AGENDA

Lincoln City Planning Commission
Tuesday, March 7, 2023, 6:00 PM
Council Chambers,
801 SW Highway 101 - 3rd Floor, Lincoln City, OR 97367

Date:	January 12, 2023
Case File:	DI 2022-02 Trout
Project Contact:	Randy Trout
Property Owner:	Jennifer L. Fowler and Keith L. Fowler
Situs Address:	2864 NE Lake Dr
Location:	Between NE Lake Dr to west and Devils Lake to east, approximately 285 feet north of NE 28 th St
Tax Map and Lot:	07-11-11-AB-00700-00
Comprehensive Plan Designation:	Medium-Density Residential District (R-7.5)
Zoning District:	Single-Unit Residential (R-1-7.5) Zone
Site Size:	5,662.80 square feet (per Lincoln County Assessor)
Proposal:	Request for director's interpretation on minimum setback requirements for a structure with more than one story
Surrounding Land Uses and Zones:	North: Houses; R-1-7.5 South: Houses; R-1-7.5 East: Devils Lake West: NE Lake Dr, Hospital; PC
Authority:	Table 17.76.020-1 of Lincoln City Municipal Code (LCMC) 17.76.020 lists a director's interpretation application as a Type I or II procedure with the Planning and Community Development Director (Director) listed as the review authority.

Appeal Staff Report for Planning Commission Public H

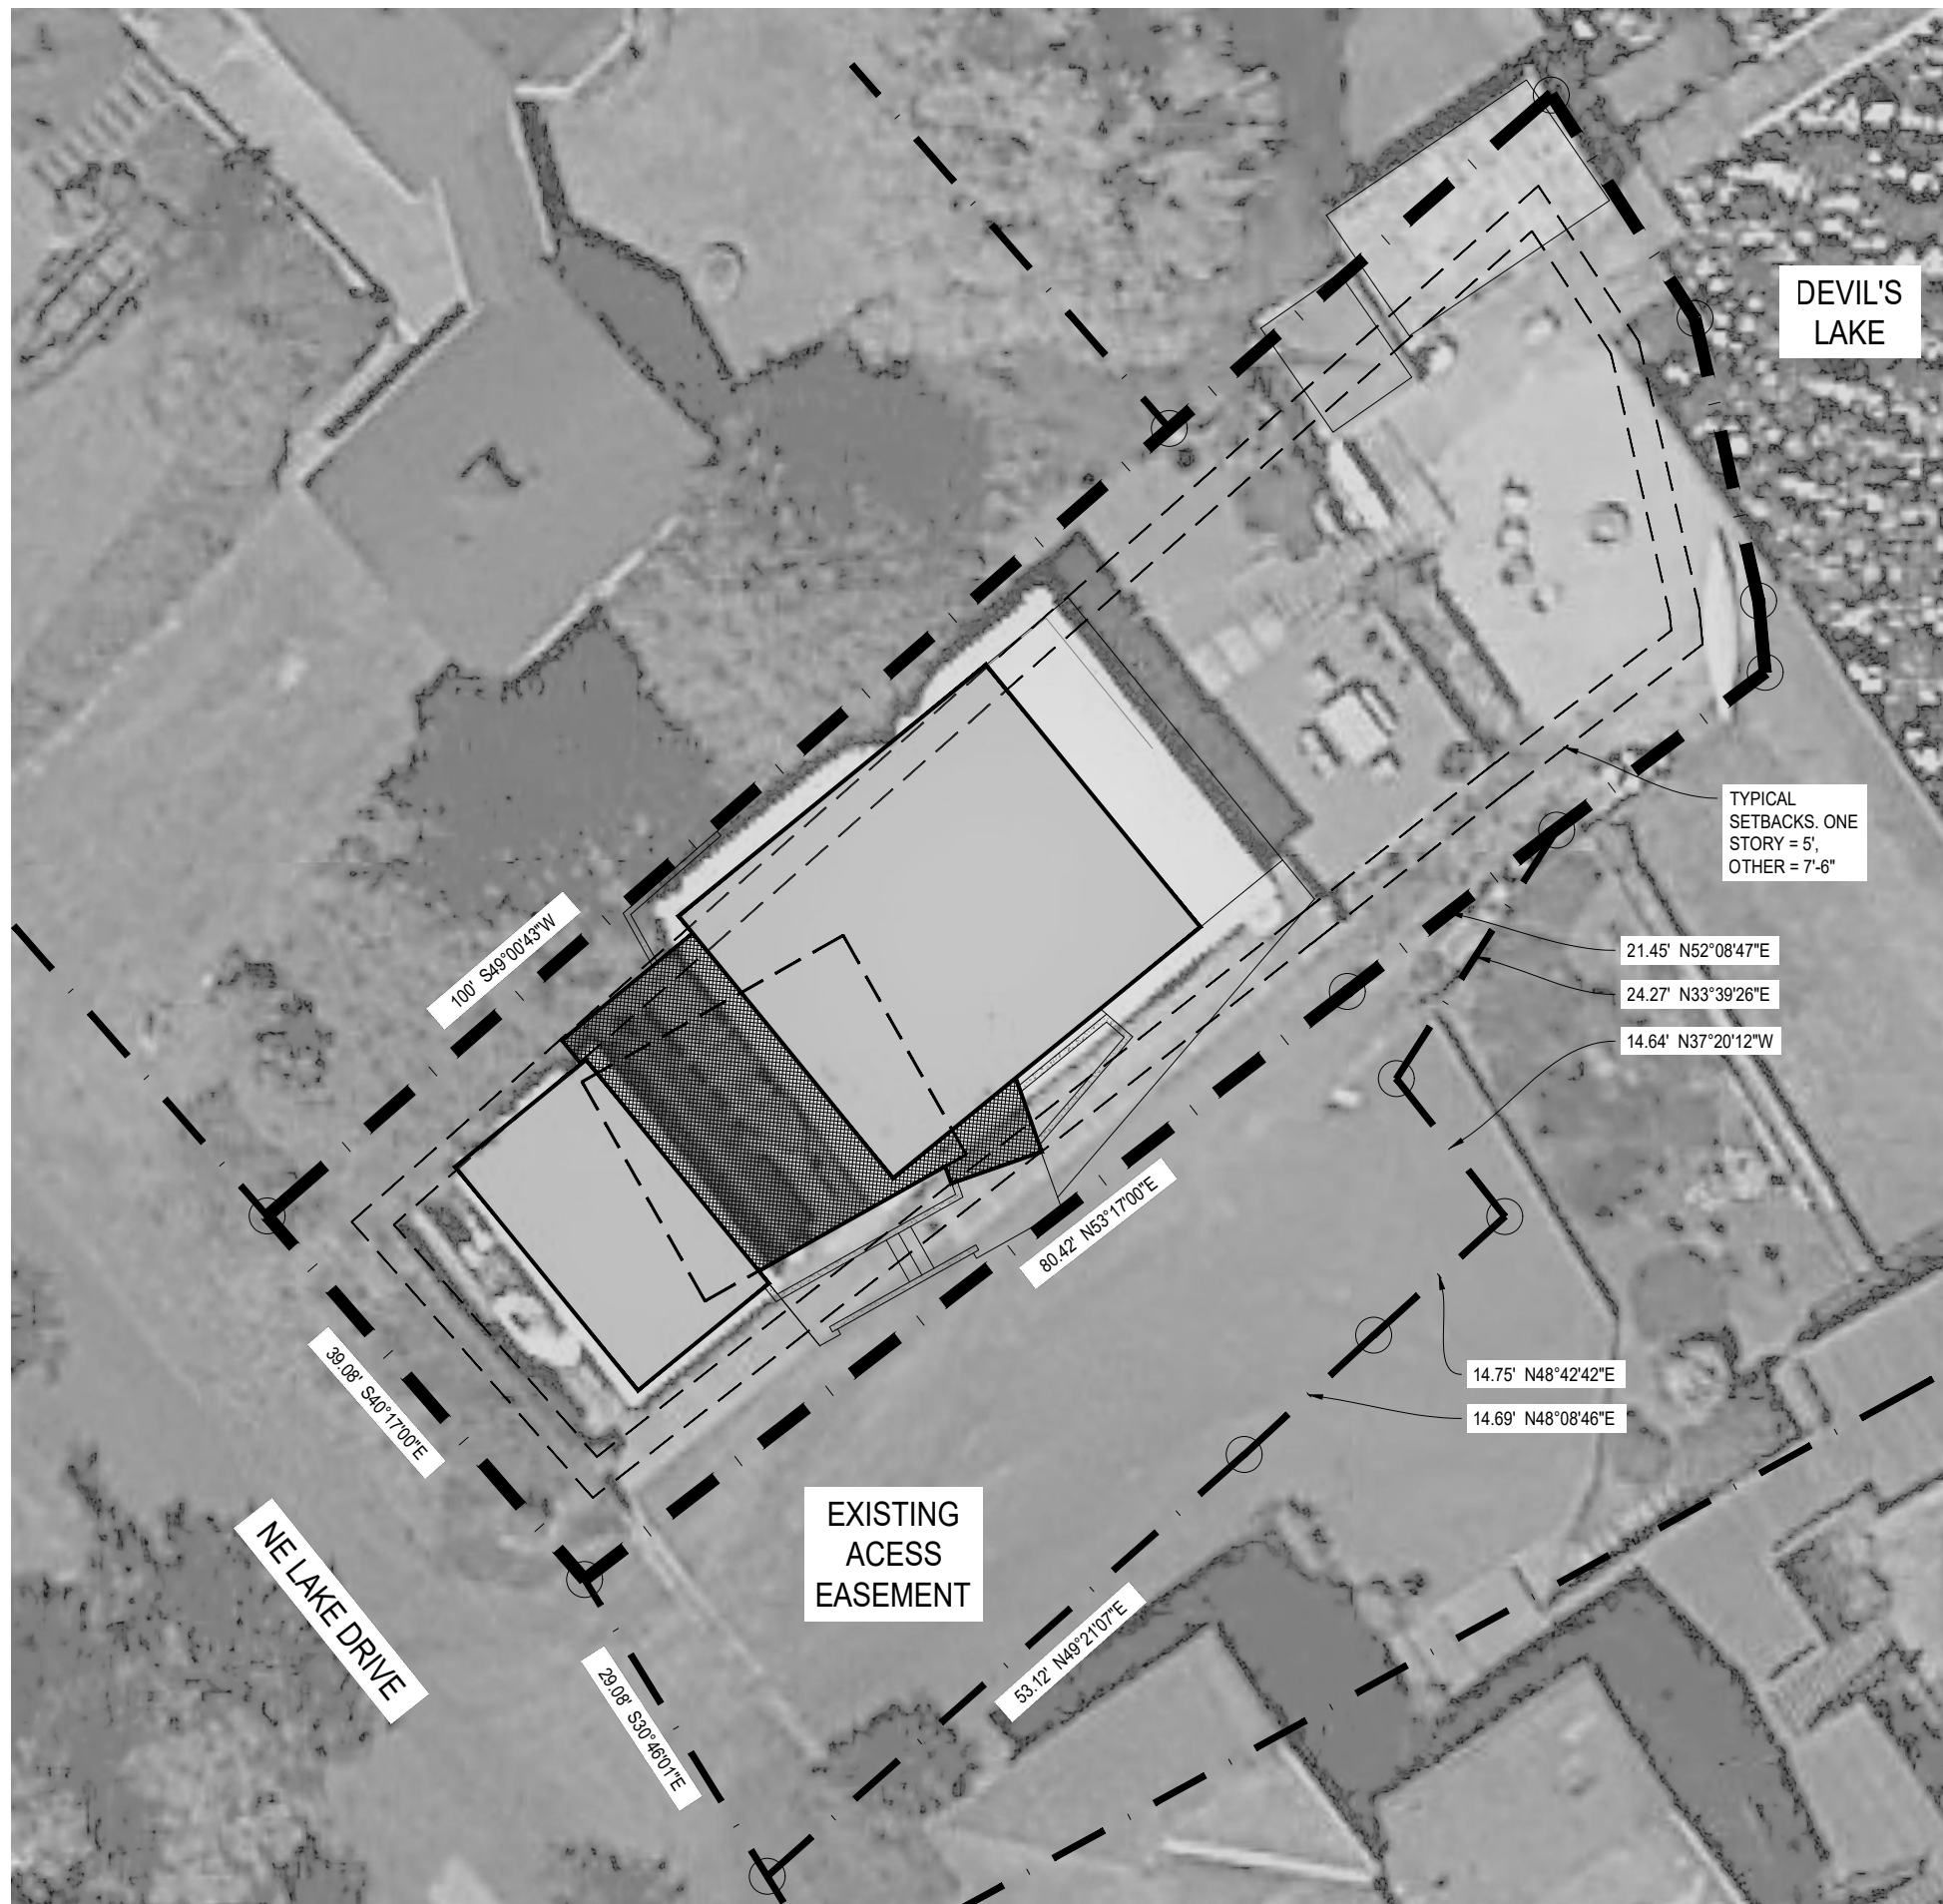
4. *height of all retaining walls need to be shown on plans.*

RESPONSE: No retaining walls are 4' high or more. Would a general note to that effect be sufficient?

SOUTHEAST ELEVATION

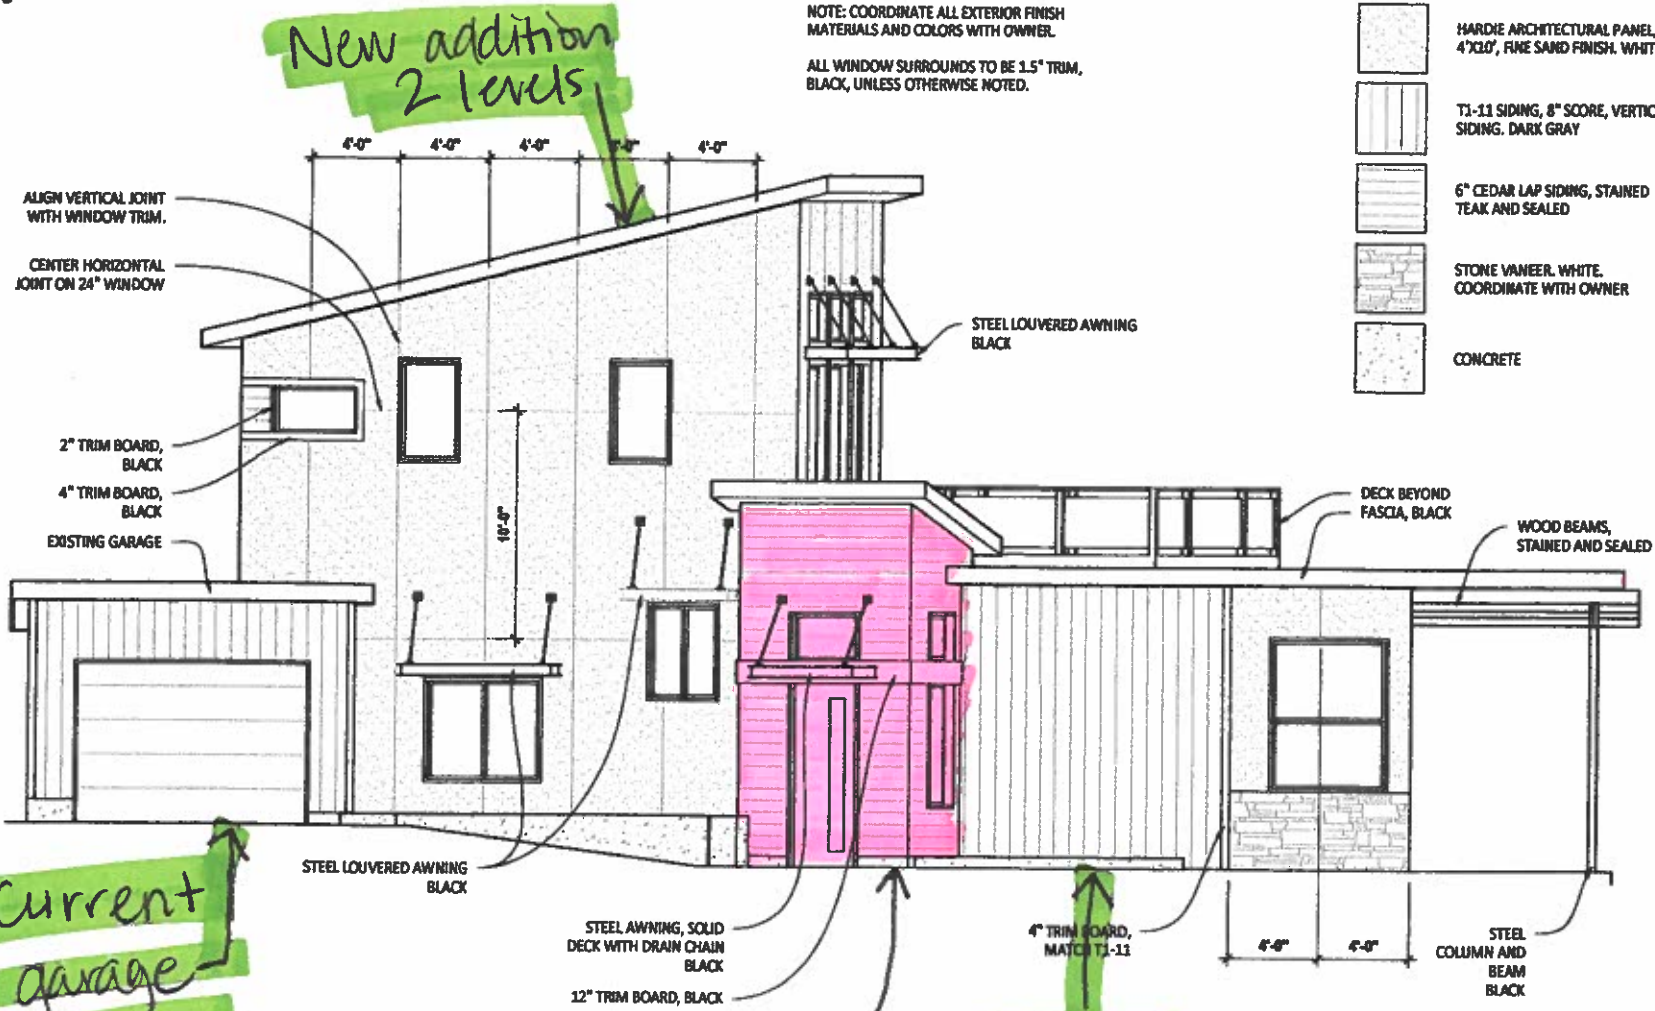
structure in
question
drawn 5 ft
back from
property line
since its 1 level

Photo A

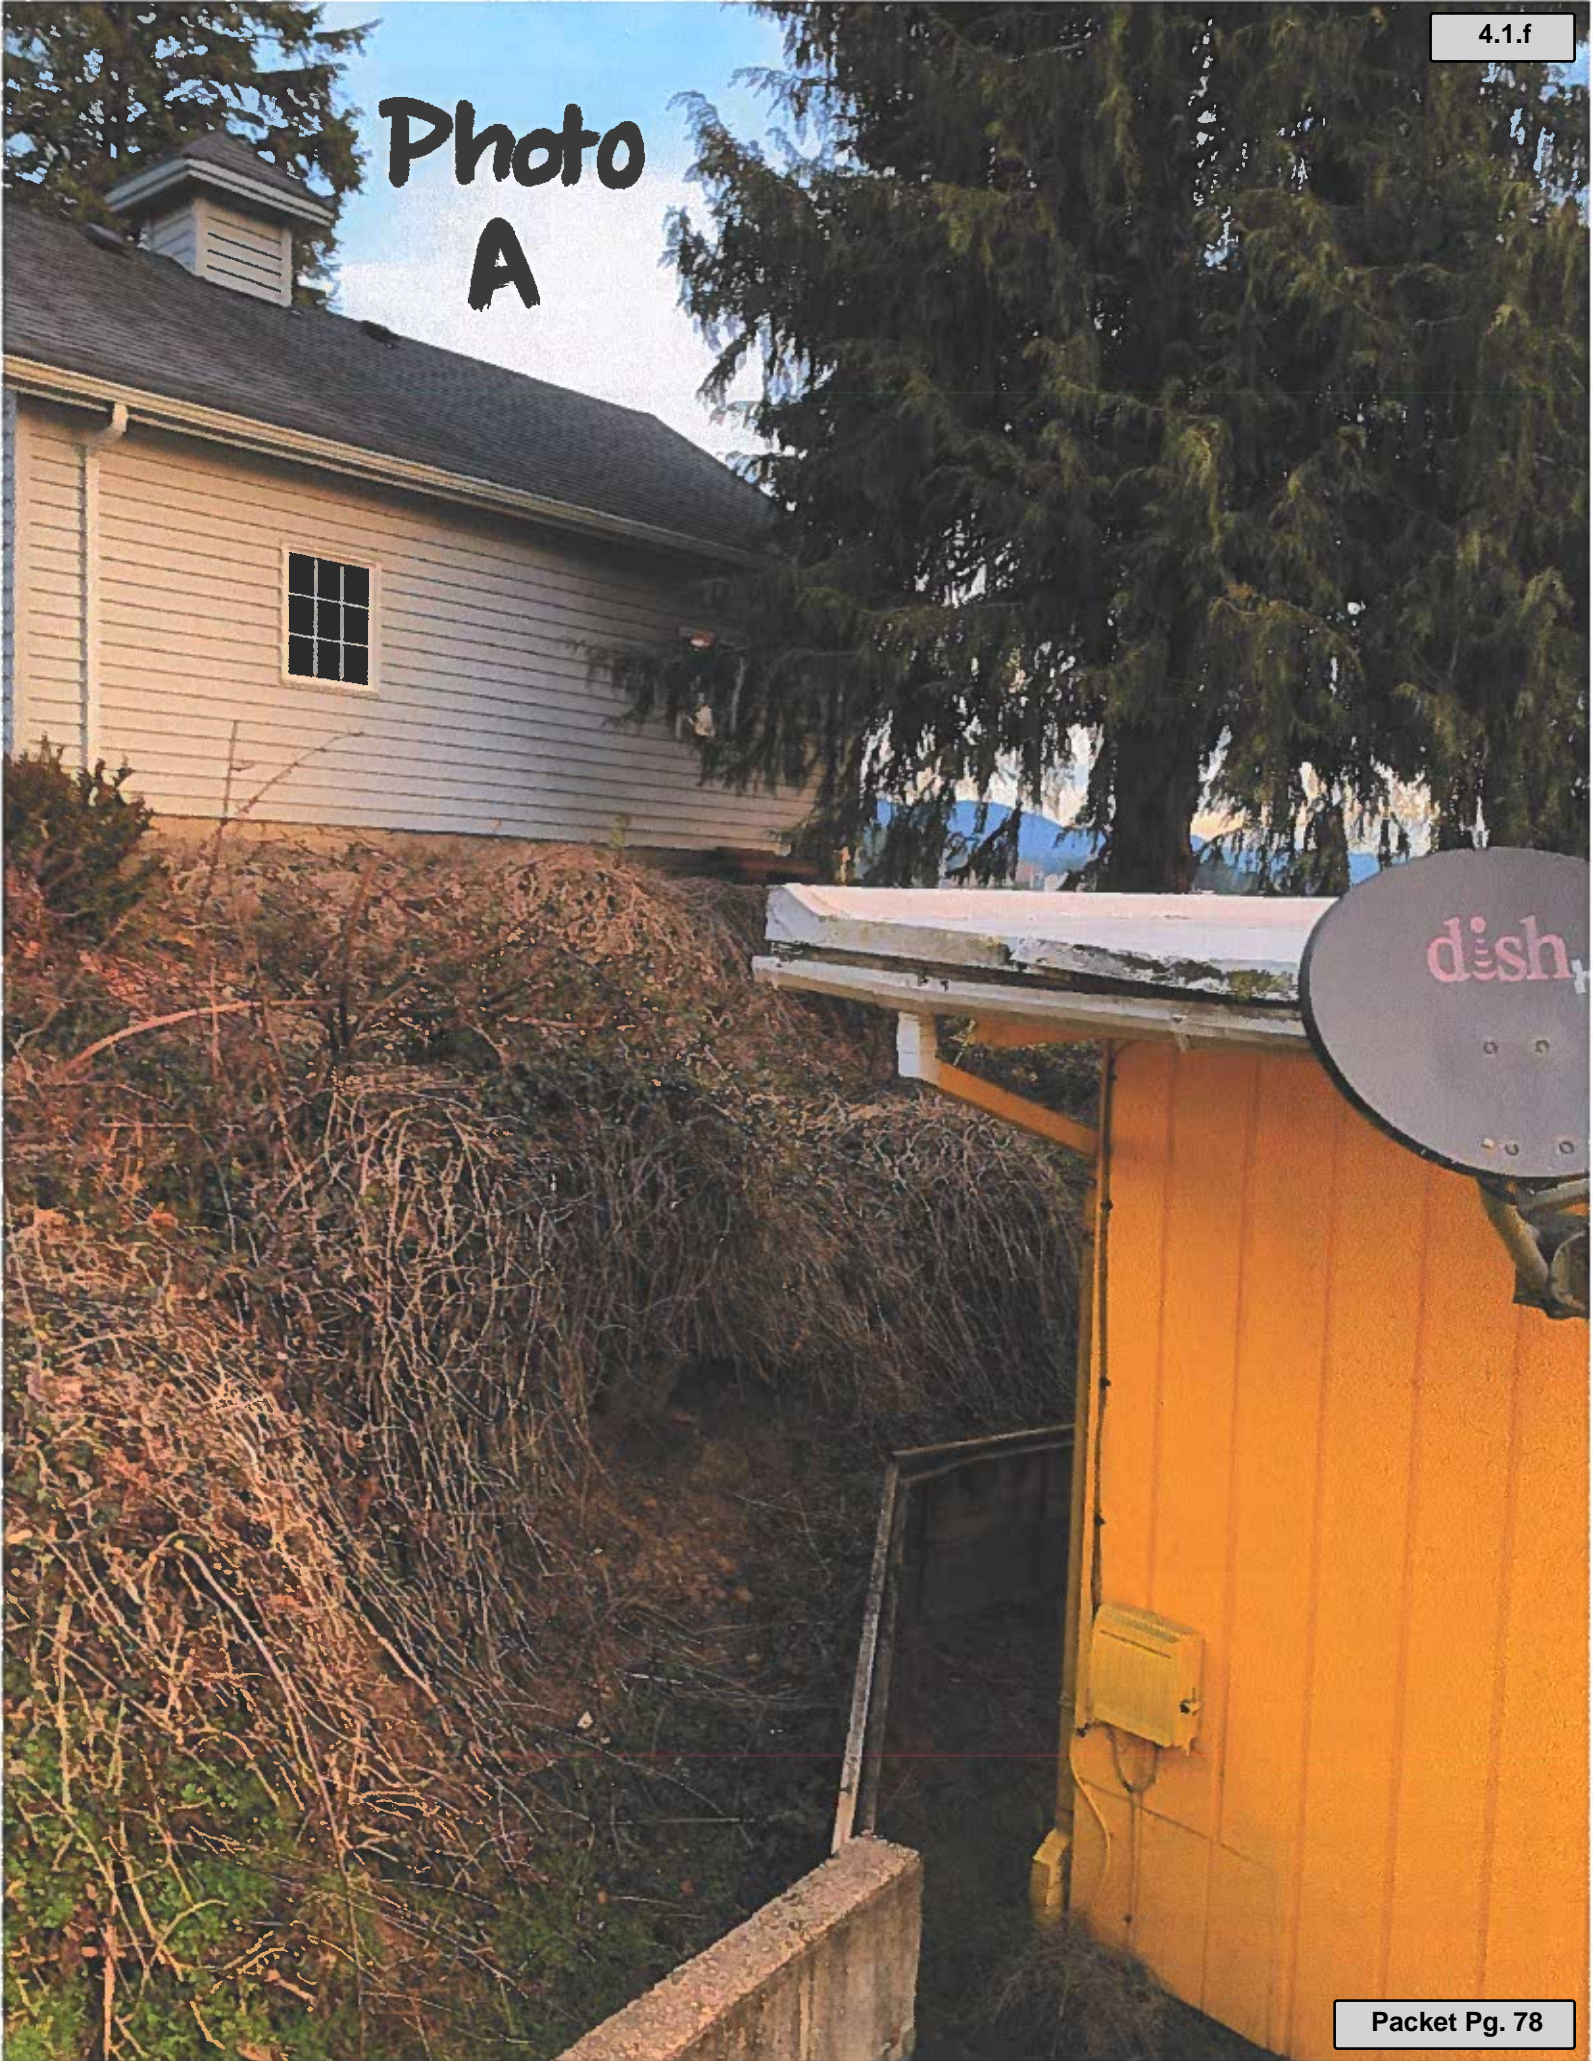
Photo A and land use plan AS101 (first story addition within 5 ft setback) demonstrates the corner of the house where the addition we are proposing does not meet the cities 7 1/2ft setback. The city approved the current 7 ½ ft code so the adjacent houses can have solar rights and protected views. As you can see from this photo, the house adjacent to us is elevated due to the land being incredibly sloped from our property up to theirs. Per photo A, the elevation of the foundation of our neighbor's home is higher than our roofline. Per photo B1 & C, the part of the addition we are proposing that infringes upon the 7 ½ ft setback is staying one level which would not cause any issue whatsoever to our neighbor's ability to add solar to their home or obstruct any views. Per photo B2, C & D, the same goes for the opposite side of the proposed addition as the lot that is adjacent to the front door area of the addition is an easement for parking and can never be built on so no solar rights or views would ever be infringed upon. We propose the code should be interpreted to allow both these 1 level portions of the new structure to be approved at the 1 level setback of 5 feet.
